Re: New Bridgewater Bridge – Major Project Public Notice

Thank you for the opportunity to provide comments on the major project impact statement (MPIS) and initial assessment report for the New Bridgewater Bridge Major Project.

Figure 1: Proposed pedestrian refuge locations

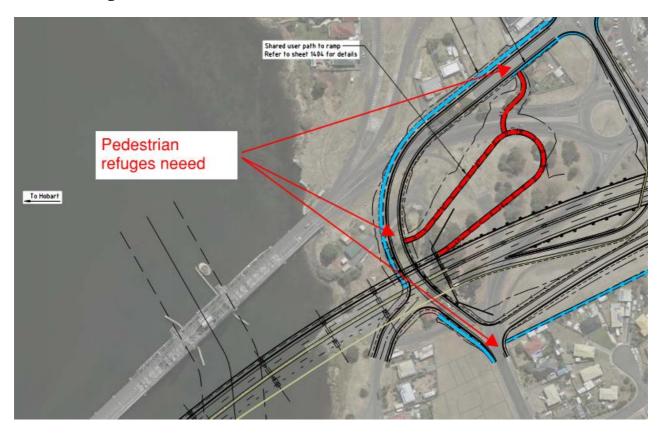
Three pedestrian refuges should be constructed by the developer as part of this Major Project and located along Gunn St where new pedestrian crossing points will be located (see Figure 1).

Figure 2: Shared path (shown in blue) to be extended to Weilly Park Rd crossing

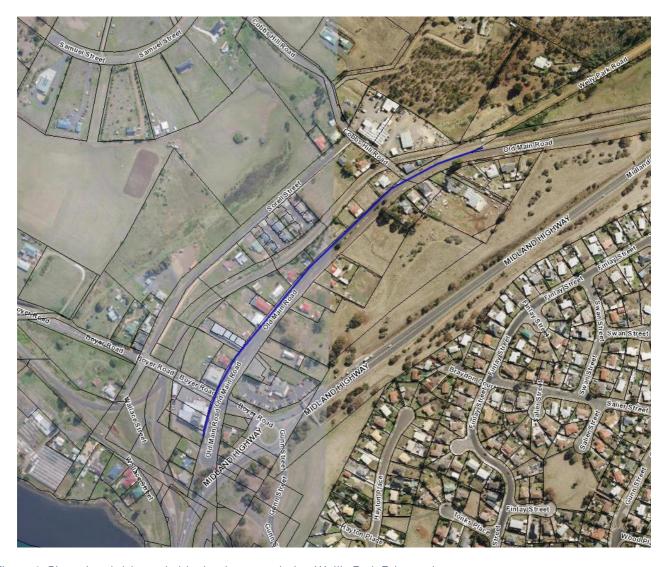
• The 2.5m wide shared user path should be extended along the northern side of Gunn St and Old Main Road to join up with the crossing at Weilly Park Road (see image below) and constructed by the developer as part of the Major Project. This will provide for a continuous shared bike paths to the Brighton Industrial Estate. Brighton Council plan to continue this through to Brighton township in the next couple of years to support residential growth.
